STAFF RECOMMENDATION
146 Ensworth Ave
May 16, 2018

Application: New construction – outbuilding/addition to existing
District: Woodlawn West Neighborhood Conservation Zoning Overlay
Council District: 24
Map and Parcel Number: 103160027.00
Applicant: Manuel Zeitlin, architect
Project Lead: Jenny Warren, jenny.warren@nashville.gov

<p>Description of Project: Application for an addition to an outbuilding that will exceed the permitted square footage.</p> <p>Recommendation Summary: Staff recommends approval of the proposed outbuilding, with the following conditions:</p> <ol style="list-style-type: none">1) Staff approve the final roofing color, chimney material, door, window, and trim; and,2) Staff approve the location of the HVAC unit, if any; <p>finding that with those conditions, the project meets the design guidelines for the Woodlawn West Neighborhood Conservation Zoning Overlay.</p>	<p>Attachments A: Photographs B: Site Plan C: Elevations</p>
--	--

Figure 3: Proposed side elevation

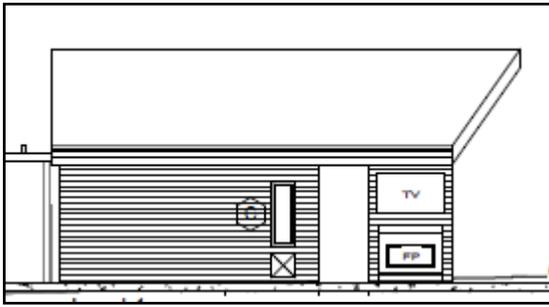
The design of the pool house is unique with a covered terrace under the projecting roofline (see Figure 3). The square footage of the pool house is approximately two-hundred and seventy (270) square feet, including the covered patio. An existing garage on the site is approximately eight-hundred and seventy-five (875) square feet, and the existing carport is four hundred and ninety-four (494) square feet. The total

combined square footage is approximately one-thousand-six-hundred and thirty-nine (1,639) square feet. Lots of more than ten thousand (10,000) square feet are limited to one thousand (1,000) square feet of outbuilding, as seen in the table above. However, in this case, Staff finds that because the lot is exceptionally large, at more than sixty-one thousand (61,000) square feet, the proposed outbuilding will not create an inappropriate amount of lot coverage, and meets the intent of the guidelines.

Figure 3: Proposed east elevation

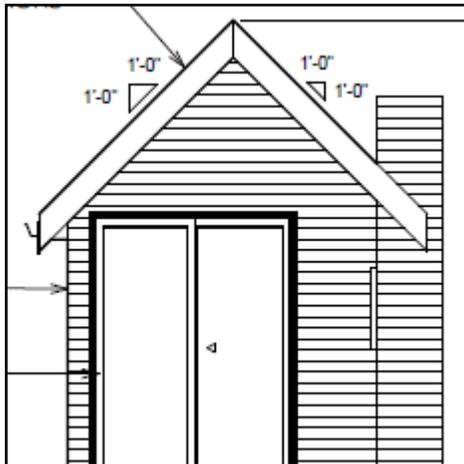
The accessory structure has a simple form that is appropriate for outbuildings (see Figure 3). Its gabled roof form, detailing, and basic rectangular form do not contrast greatly with the primary structure. The finishes are modern, but still compatible with a clear stain on the siding, single-light vertical window and sliding glass door. These details may not be appropriate for the primary façade of a historic home, but as they are not publicly visible, they are appropriate in this location. The proposed design of the outbuilding does not contrast greatly with the surrounding historic buildings and therefore meets Section II.B.1.h.1.

The known materials are appropriate for an outbuilding in Woodlawn-West, except for the chimney. Chimneys are required to be masonry; therefore staff recommends stone, brick or stucco for the chimney cladding. Also, there is no mention of trim; Staff recommends four inch (4") nominal corner boards and casings around the door and window and corners?. Staff finds that with final review of the roofing color, chimney material, door, window, and trim, that the outbuilding meets Section II.B.1.h.1 in terms of materials.

- 1) Staff approve the final roofing color, chimney material, door, window, and trim; and,
 - 2) Staff approve the location of the HVAC unit, if any;
- finding that with those conditions, the project meets the design guidelines for the Woodlawn West Neighborhood Conservation Zoning Overlay.

Revised site plan detail, showing foot print of carport

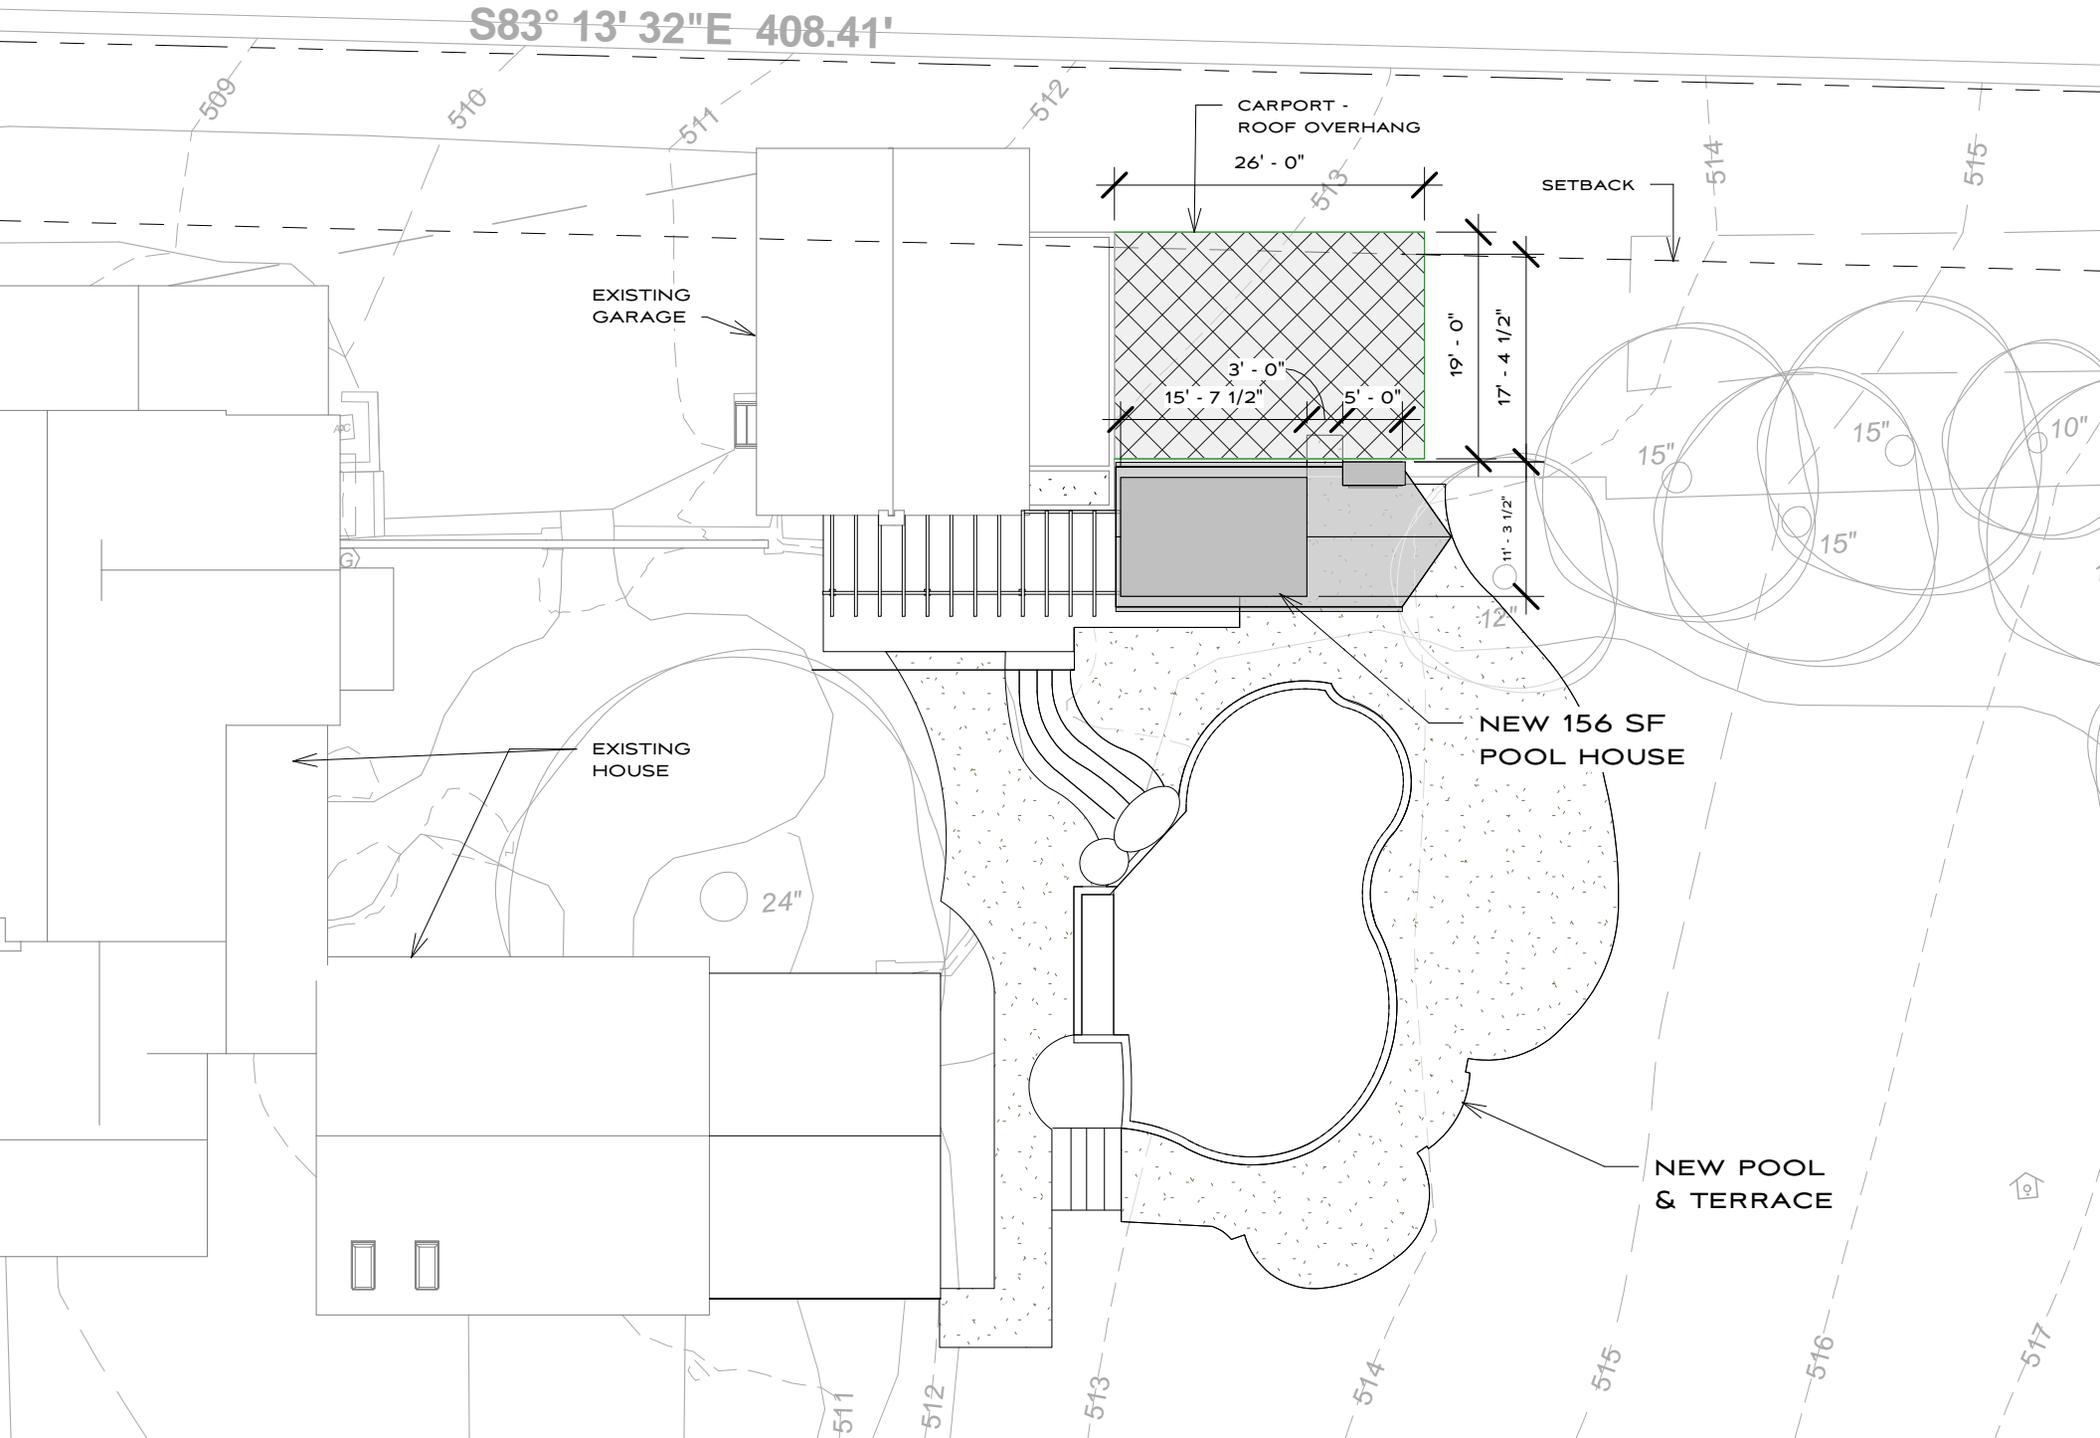
Analysis and Findings: A permit was recently issued at the staff level for an addition to the principal dwelling. This application is for the construction of a small pool house with a square footage of approximately two-hundred and seventy (270) square feet to be added adjacent to the existing outbuilding. Per the guidelines, lots more than ten thousand square feet (10,000 sq ft) may have outbuildings with a total footprint of one thousand square feet (1,000 sq ft). In this case, due to the existing garage and carport on the lot (see Figure 2), the total square footage will exceed the one thousand (1,000) square foot maximum.

Outbuilding more than 750sq ft in foot print	Minimum Rear/Alley Setback	Minimum Side Setback for interior lot lines	Distance Between Principal Building and Outbuilding
Required	20'	5'	20'
Proposed	~140'	~105/~35'	~60'

The proposed structure will meet all of the setback requirements and is in an appropriate location for an outbuilding in Woodlawn-West. The project meets section II.B.1.h.2 of the design guidelines for setbacks and site requirements.
